PIC18F87J11 Family Silicon Errata and Data Sheet Clarification

The PIC18F87J11 family devices that you have received conform functionally to the current Device Data Sheet (DS39778D), except for the anomalies described in this document.

The following typographic corrections and clarifications are to be noted for the latest version of the device data sheet (DS39778D):

FIGURE 19-10: I²C™ SLAVE MODE TIMING (TRANSMISSION, 7-BIT ADDRESS)

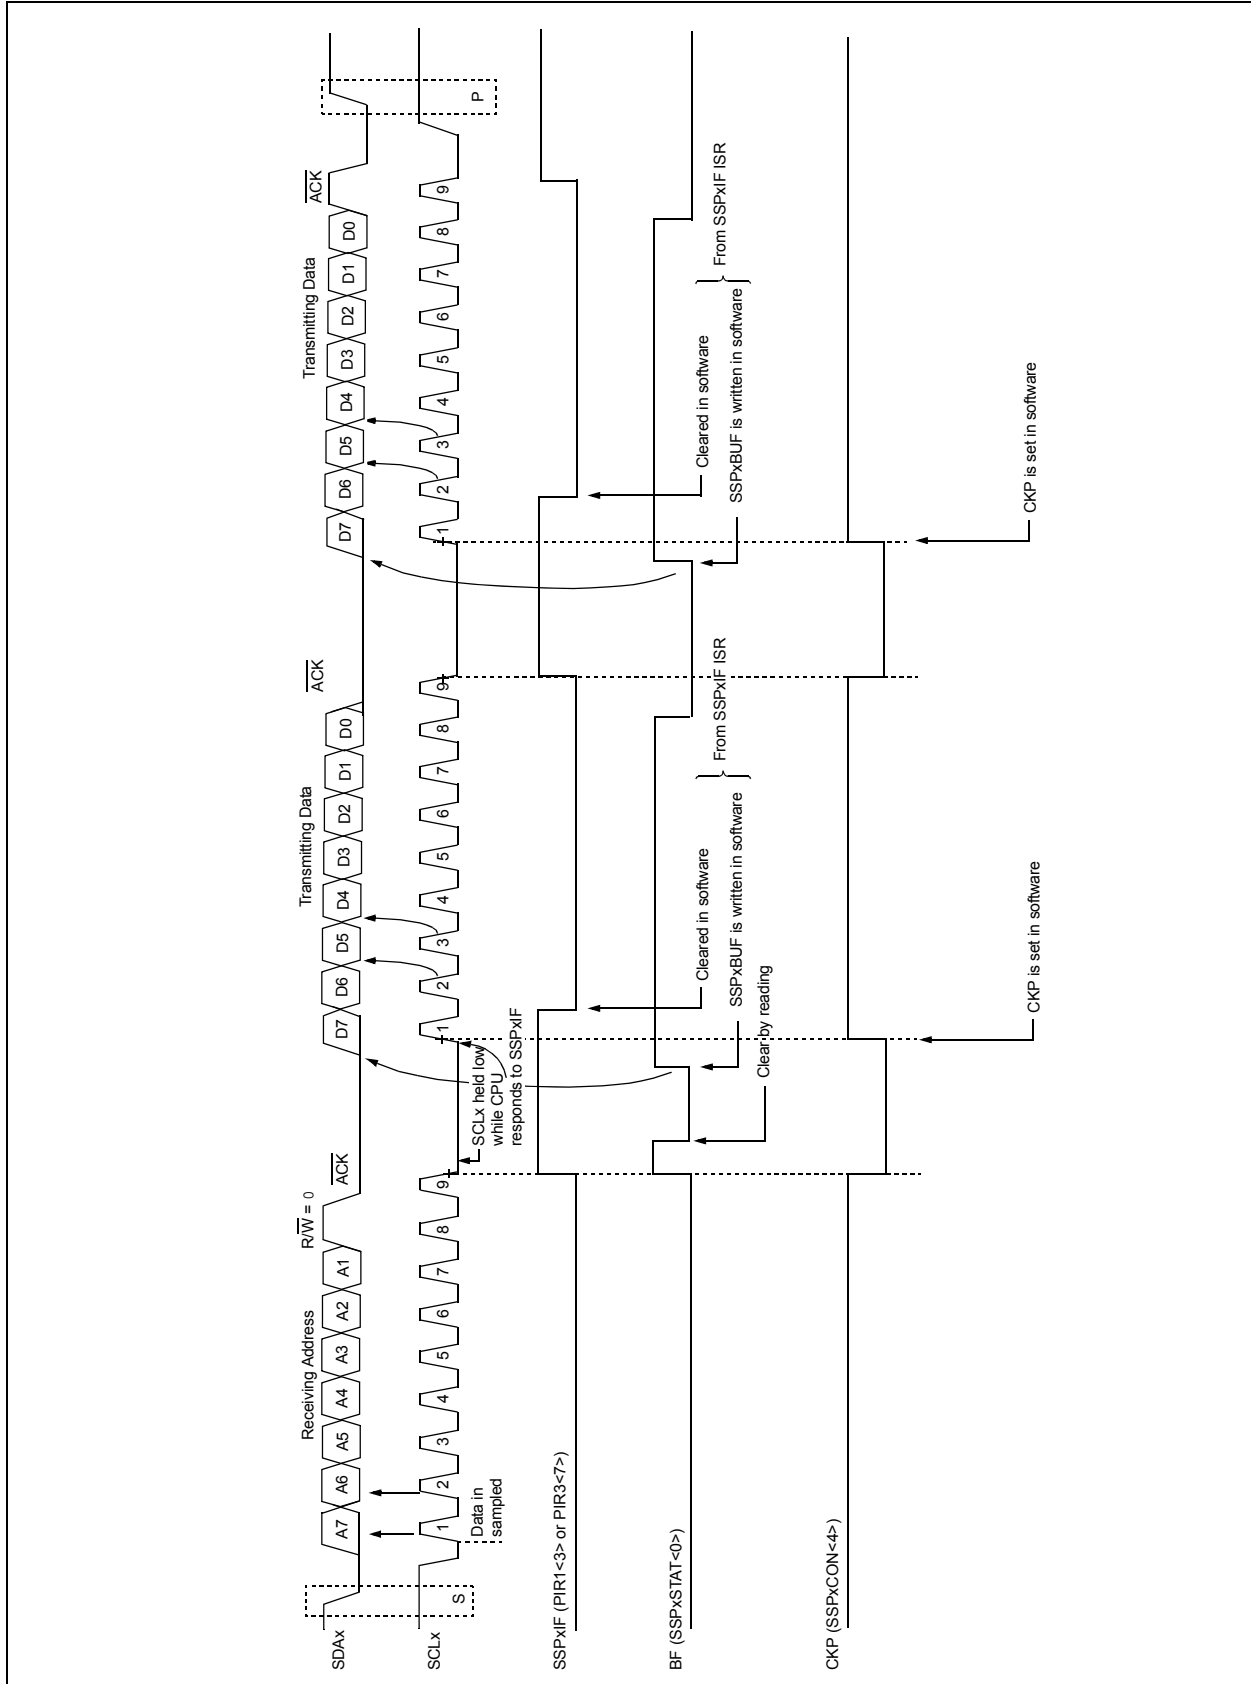
7. Module: Figure 19-10: I²C™ Slave Mode Timing (Transmission, 7-Bit Address)

On page 244, the figure is replaced with the new timing diagram provided in [Figure 19-10](#).

FIGURE 19-24: I²C™ MASTER MODE WAVEFORM (RECEPTION, 7-BIT ADDRESS)

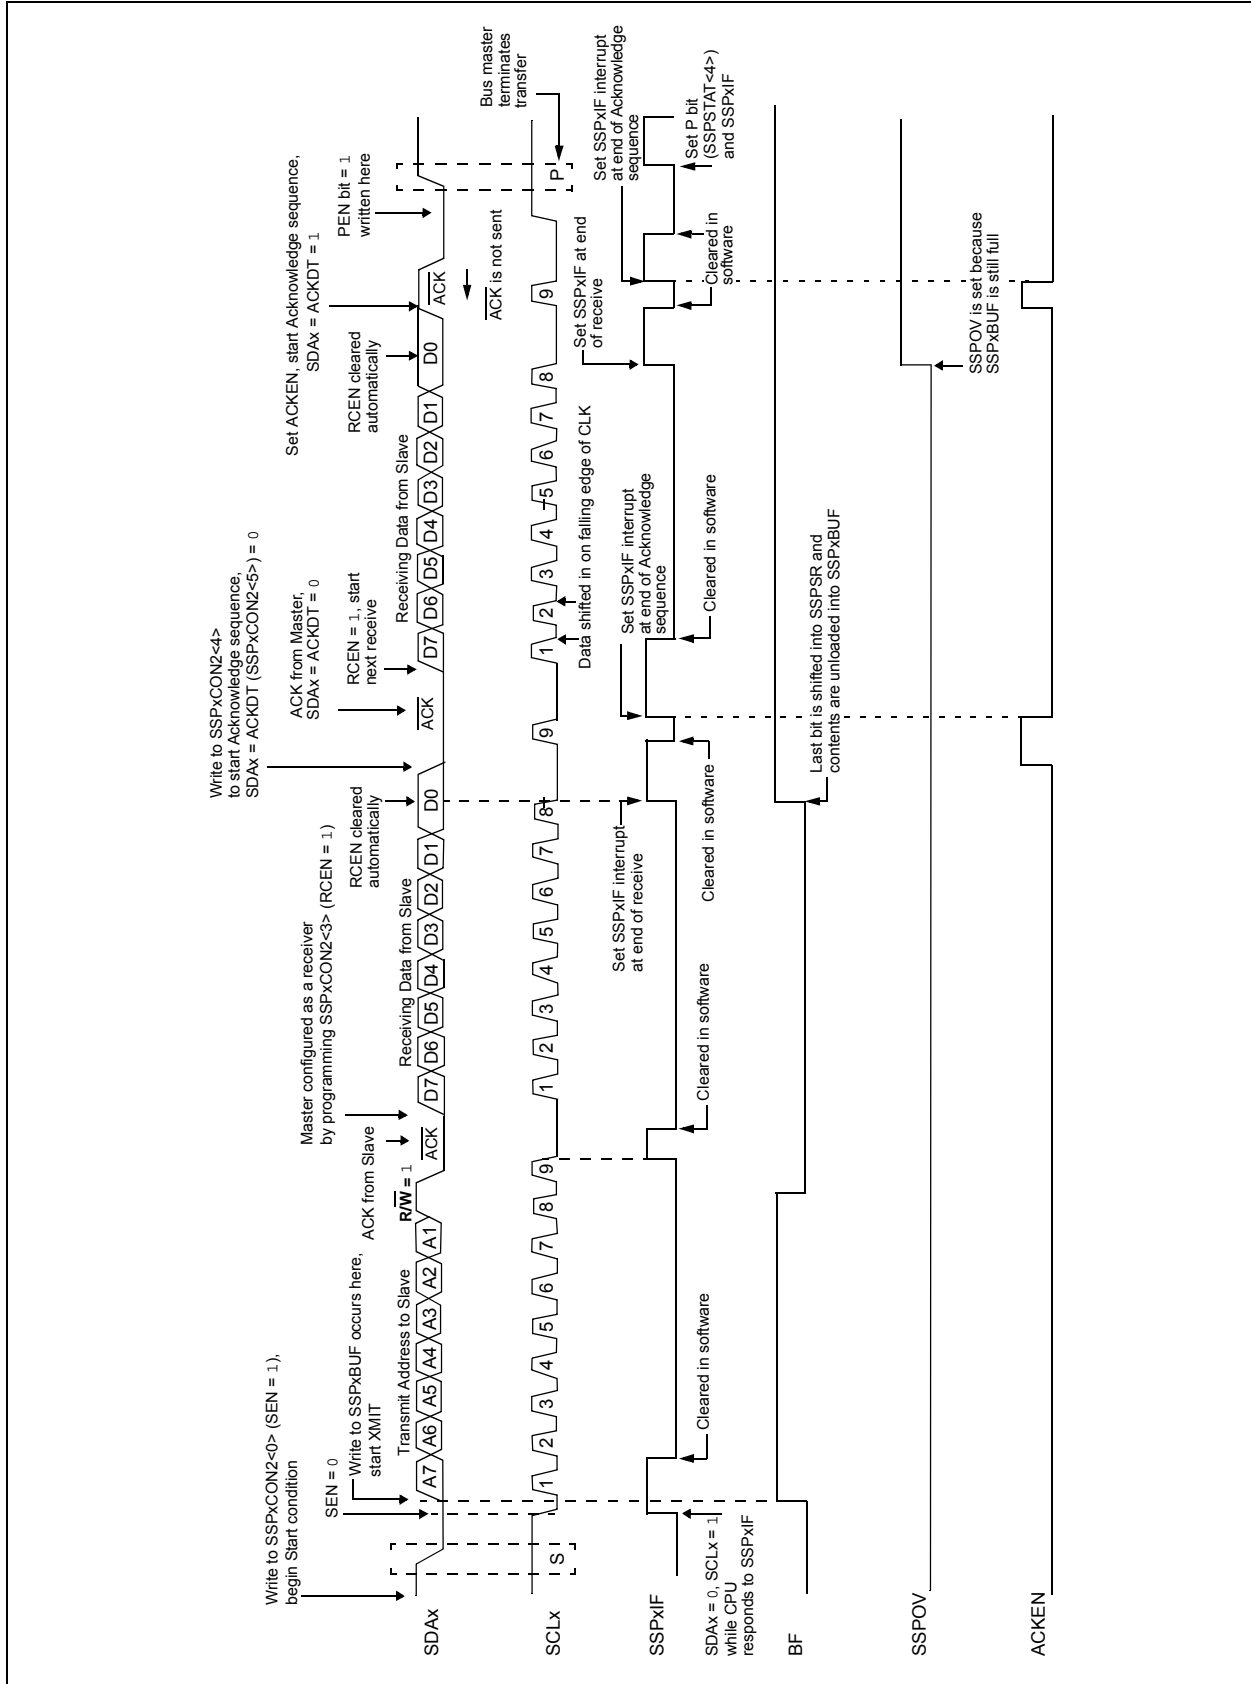
8. Module: **Figure 19-24: I²C™ Master Mode Waveform (Reception, 7-Bit Address)**

On page 261, the condition (R/\overline{W}) when the Acknowledge signal (ACK) is received from the slave, after transmitting the address to the slave, is changed to '1'. The changed value is indicated in bold text in [Figure 19-24](#).

FIGURE 5-7: DATA MEMORY MAP FOR PIC18F87J11 FAMILY DEVICES

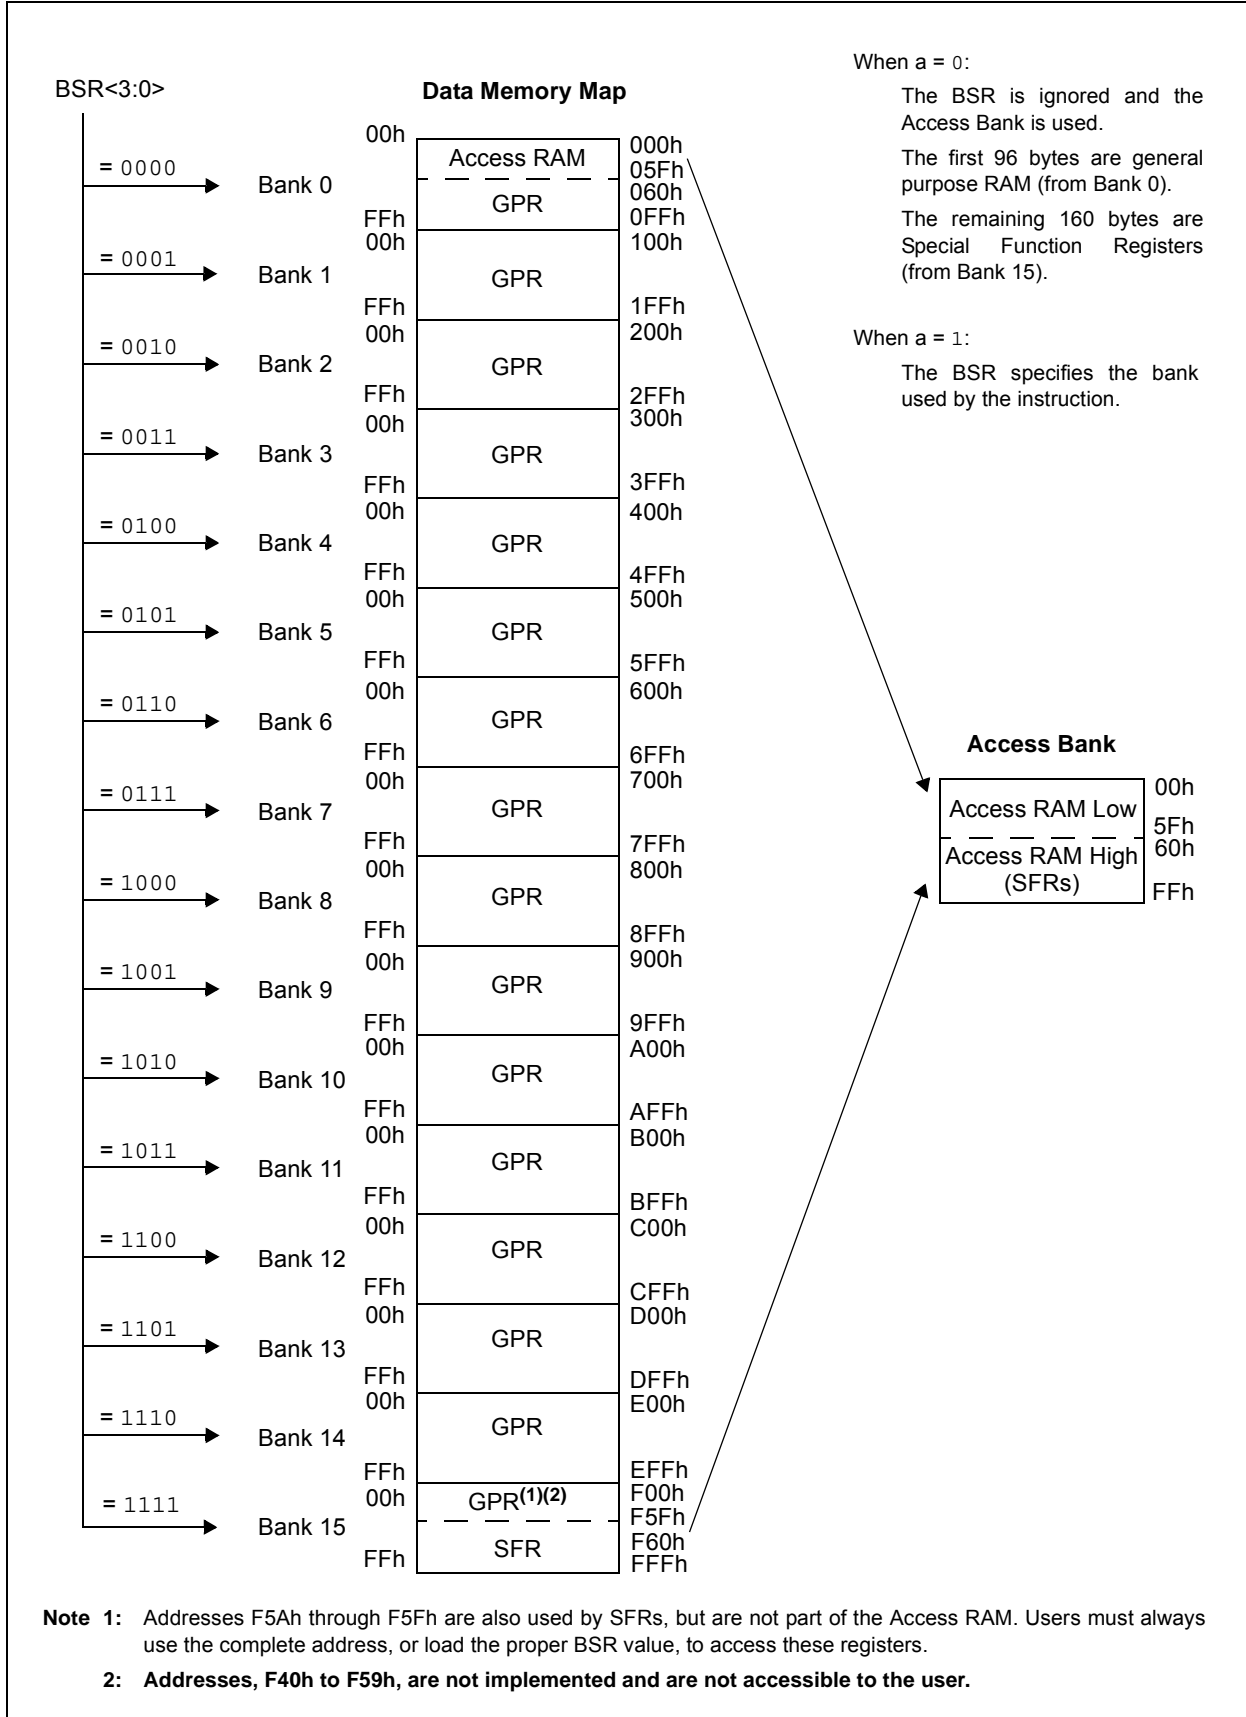
11. Module: Memory Organization

On page 73, in Figure 5-7, Note 2 has been added. The additional note is indicated in bold text in Figure 5-7.
